**Case #:** PB 2017-05-R1 (08/18)

**PLANNING STAFF REPORT**

**Site:** Assembly Row Block 5B – Grand Union Boulevard

Legal Notice: Applicant and Owner, Street Retail Inc., seek a Revision to a Special Permit with Site Plan Review–A under SZO Article §6.4.11 and §5.2 to increase the commercial floor area to approx. 292,890 sf office space (previously approved 267,600 sf) and make related changes to building design and parking.

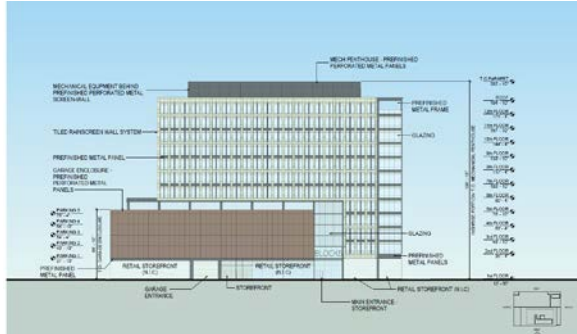
The revisions to the ground floor plan are minimal and will not be noticed from any of the public right-of-way. The vehicular exits/entrances are in the same locations and only the loading docks have been modified.

The necessity of this edit was to provide transformer access that was requested by the utility company. There is no change in number of loading docks from the previous approval.

Revised west elevation

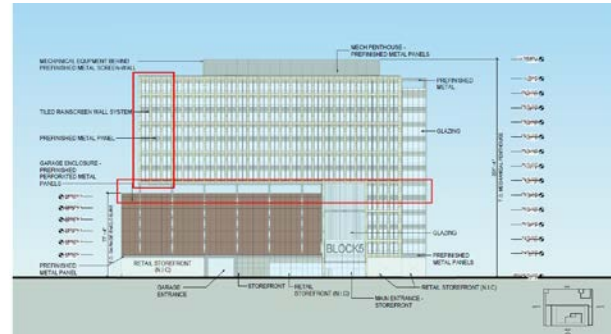
The floor plates on the upper floors are enlarged by just over 3,000 sf and the 6<sup>th</sup> floor is expanded to accommodate parking for the additional office space (as shown in the elevations below). The total increase in floor area of the building is approximately 25,500 gsf.

Enlarging the building to increase commercial floor plate for a more marketable building is a good revision. The footprint and urban design elements remain the same, so the streetscape and pedestrian interaction with the proposed building does not change from the previous approval.
